Re: Response to Comments on the Applications for Modification 22-1 to Little Rock Mine, Permit No. GR007RE; and Modification 22-1 to Tyrone Mine, Permit No. GR010RE; Freeport-McMoRan Tyrone Inc.

Freeport-McMoRan Tyrone, Inc. (Tyrone) applied for a modification to the Little Rock Mine Permit No. GR007RE on August 2, 2022. The application requested approval of the Little Rock Precambrian granite to be used as Reclamation Cover Material (RCM) at the Little Rock Mine and to terminate the USNR Test Plot Study. On August 17, 2022, Tyrone also applied for a modification to the Tyrone Mine Permit No. GR010RE for approved use of the same RCM at the Tyrone Mine.

Image 1. Seeded bench of 9A with 9AX in the background, December 2022.

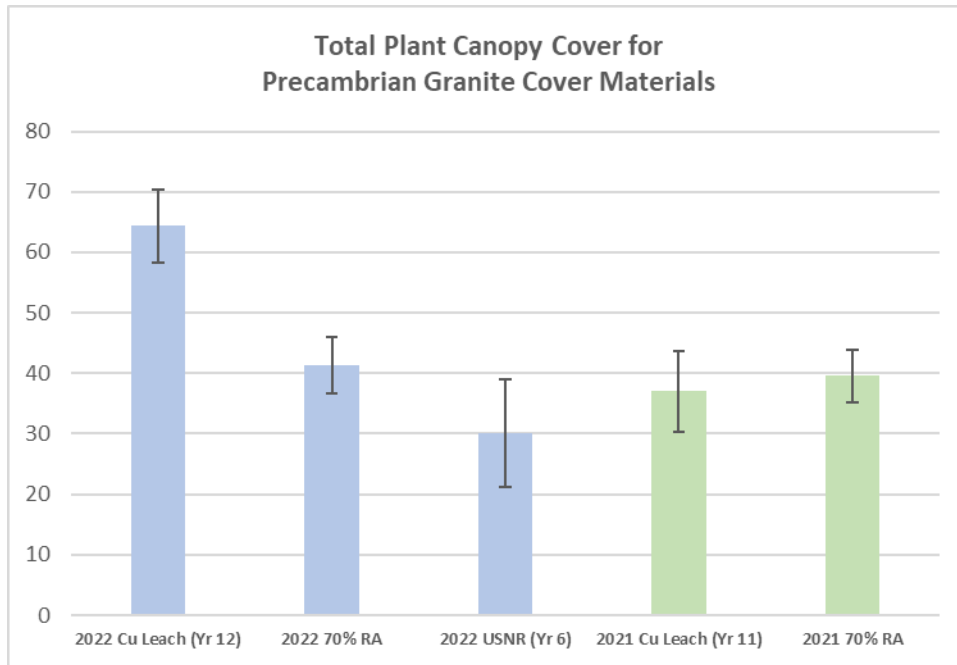
- 2. Results, Reclamation Cover Material Suitability, pages 4 and 5 states that physical and chemical characteristics of the Precambrian granite placed at the USNR Test Plots and the Gila conglomerate RCM were evaluated. The Precambrian granite waste rock excavated from the Little Rock Mine has been hauled to the Tyrone Mine and placed onto the Tyrone 9A and 9AX Stockpiles. Prior to approval of the Precambrian granite in the 9A and 9AX stockpiles as RCM, MMD requests that Tyrone performs confirmation sampling and analysis of the Precambrian granite in these waste rock piles. Tyrone shall provide a sampling and analysis work plan to MMD within 90-days for the chemical and physical sampling and analyses that will be performed.*

Finally, compelling information can be obtained by visual observation of the 9A and 9AX stockpiles. Vegetation is establishing voluntarily on the stockpile benches in good abundance, indicating it is a favorable growth medium. Please see Image 1 and 2 below that show this establishment on the 9A Stockpile. Photographs of the 9AX were not taken due to the inaccessibility of the stockpile.

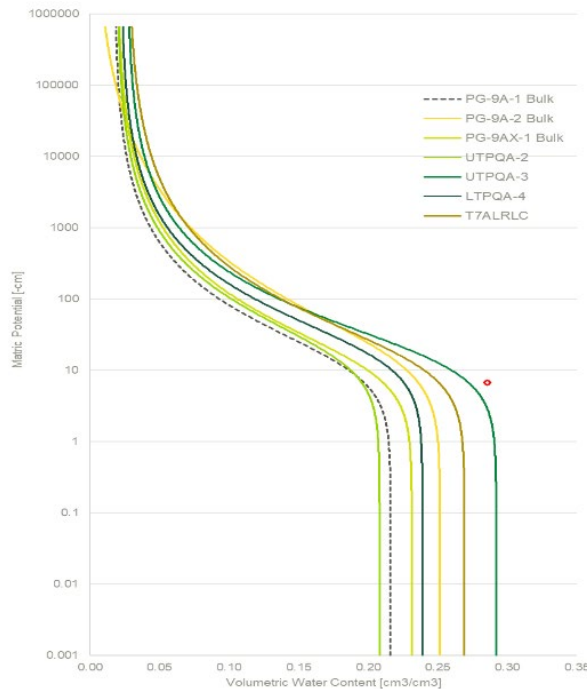
3. *Condition 8.P.1(a) of Permit Modification 17-1, for the Little Rock Mine, Permit No. GR007RE requires that Tyrone provide the results to MMD of the 2018 and 2020*

USNR Test Plot and the Tyrone reference area quantitative vegetation monitoring. MMD has received reports from Tyrone of the 2018 and 2020 quantitative vegetation monitoring results. The 2018 USNR Quantitative Vegetation and Erosion Monitoring Report for the USNR Test Plot Study, dated April 25, 2019, did not include a vegetation survey of the Tyrone reference area. Therefore, MMD requests that Tyrone performs a quantitative vegetation survey at the USNR Test Plots and the Tyrone reference area in 2023 to compensate for not performing a vegetation survey of the Tyrone reference area in 2018.

Tyrone discussed this comment with MMD in the virtual meeting held on December 5, 2022 and expressed concern that performing another study on the test plots in 2023 would significantly delay this process as the results would not be available until early 2024. Tyrone asked for an exception to this permit condition and for conditional approval based on the results of the 2022 vegetation monitoring surveys conducted on the USNR and Copper Leach Stockpile. The USNR and Copper Leach Stockpile sites were constructed with the same cover material from the Little Rock Mine and seeded in 2016 and 2010, respectively. A summary of the 2022 surveys is provided below. It is important to note that observations from these sites are equally as important as the test plots and can serve as an alternative solution to conducting additional vegetation monitoring in 2023.

The figure below compares the 2021 and 2022 total canopy cover (\pm the 90% confidence interval) for Precambrian granite reclamation to the reference area performance standard. In 2021, a drought year, total canopy cover on the Copper Leach Stockpile (Year 11) was just shy of the reference area standard. Canopy cover for the reclamation at the Copper Leach stockpile (Year 12) in 2022 is significantly higher than the reference area. Year 6 for the USNR reclamation is 73% of the reference area standard in 2022 and the 90% confidence intervals overlap, suggesting the means may not be significantly different.
